Re: City of Austin Urban Forestry Board Recommendations For The Locating  
Of Art In Public Places (AIPP) And Related Structures Near Trees

RE: Brush square Oak, by o Henry and suzanna Dickinson museum

## Tree Permit

Grade Was Raised Significantly in 2010 Over CRZ of Brush Square Tree

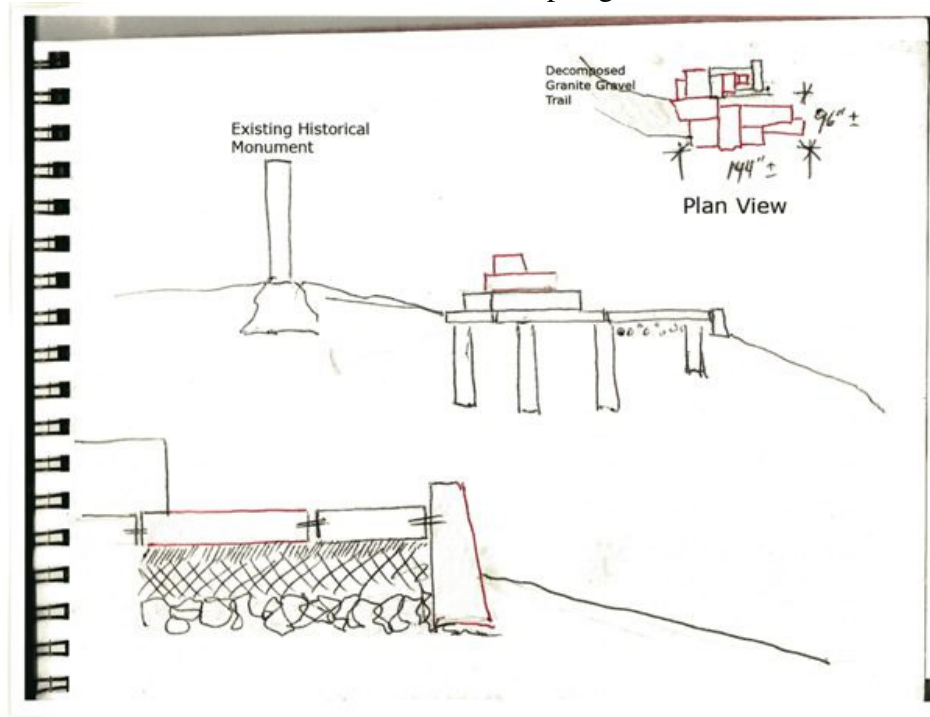
The Brush Square heritage live oak was impacted by the installation of the AIPP Stone Courtyard built in 2010. This tree is declining and needs remedial work to prevent the additional decline that is expected to occur if corrective measures are not implemented in the near future. Please refer to the attached Tree Assessment Report from certified arborist Vincent Debrock, Heritage Tree Care. Mr. Debrock explains that the 44-inch- diameter live oak shows pale leaves and a thin canopy (70% of original density), but no signs of problems caused by insects or other tree-related diseases. The stone courtyard (the AIPP artwork) extends over a large portion of the root zone of the tree, reducing water availability to the roots with the significant impervious cover from the concrete, stones, and grade changes.

The tree permit that was approved by the City Arborist (attached) for this work required that no cut or fill work be done within the inner one-half of the CRZ. It was intended that the root zone be protected from machinery and trucks to avoid soil compaction. The City Arborist and the Parks And Recreation Department (PARC) recall that the artist, as well as the AIPP-overseeing staff, agreed not to dig within that inside half of the CRZ and that no roots would be cut. However, photographs show that there was significant digging (more than 2 ft. deep) within that area. In addition, the grade was raised by several inches within the CRZ. This tree did not receive soil aeration prior to this work. A large amount of fill was added over the compacted soil, and a significant part of the root zone was covered with impermeable heavy stone; making it very difficult, if not impossible, for the roots to get water. The resulting 1/8-inch spacing between the stones is too small to allow the passage of sufficient water. The decline of this tree

demonstrates that these roots have been affected by all of this work. Photographs are attached, and you will note that machinery and trucks are shown working within the root zone of the tree.

8 photographs provided by the museum curator showing the construction process. Grade changes are larger than 8 inches through a significant area of the CRZ. The patio coverage is made up of thick limestone slabs tightly juxtaposed with marble slabs. Joints are approximately 1/8 ". No information has been provided regarding root zone impact and mitigation actions during the project other than these photos.

The patio art work with its grade changes and significant impervious also reduces water availability.

The extensive site changes since 2009 are impacting the overall health of the tree. We expect more gradual decline in the coming years if corrective measures are not implemented. These measures should strive to provide a healthier root system. These can include a combination of several elements:

- Root wells through the changed grade and stone patio area
- Soil improvement with compost and mulch
- Compaction remediation and prevention with airspade and incorporation of 1' layer of sand and 1" layer of compost through the available critical root zone.

## Artist's Sketches For Overlook Construction Within CRZ Of Heritage Pecan Tree In South Lawn Of Barton Springs Pool

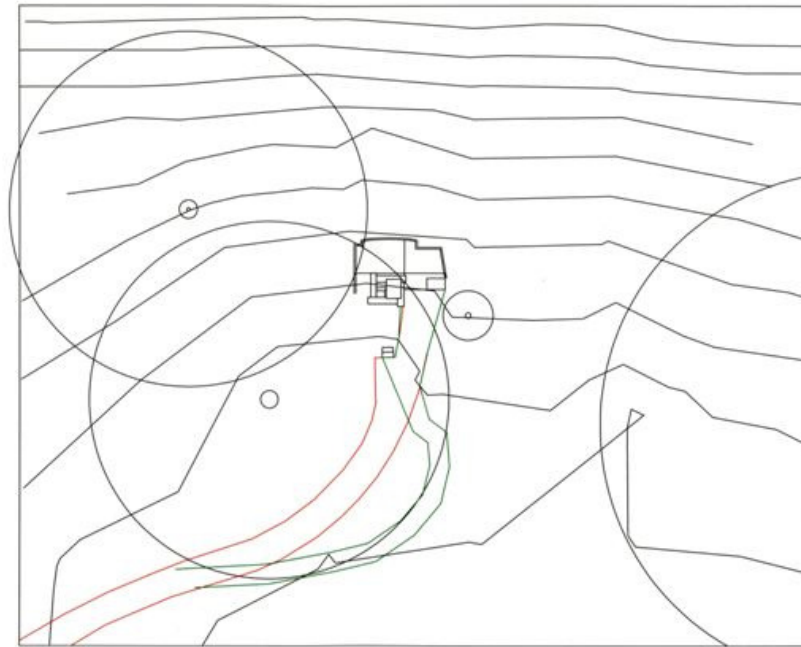
The second case brought to our attention is the heritage pecan on the south lawn of Barton Springs Pool. Artwork was to be installed within the CRZ of this tree in spite of PARD recommending numerous times over several months that it not be done. The installation of an overlook to serve as a base for the artwork required digging within the CRZ of this tree over a large area, but no certified arborists, landscape architects, or engineers were involved in the design. The artist submitted several sketches of the installation (attached). Acting PARD Forestry Manager Angela Hanson explained during a public review meeting that heritage trees already stressed by drought should not endure the additional stress of having artwork installed within their CRZ. It was not until more than 40 concerned citizens protested against this artwork at a public meeting, that it was moved from underneath the tree canopy and located outside the pool fence.

We are therefore recommending that the management and staff charged with administering the AIPP Program take immediate steps to ensure that artwork and related structures not be allowed to be built again within the CRZ of any tree.
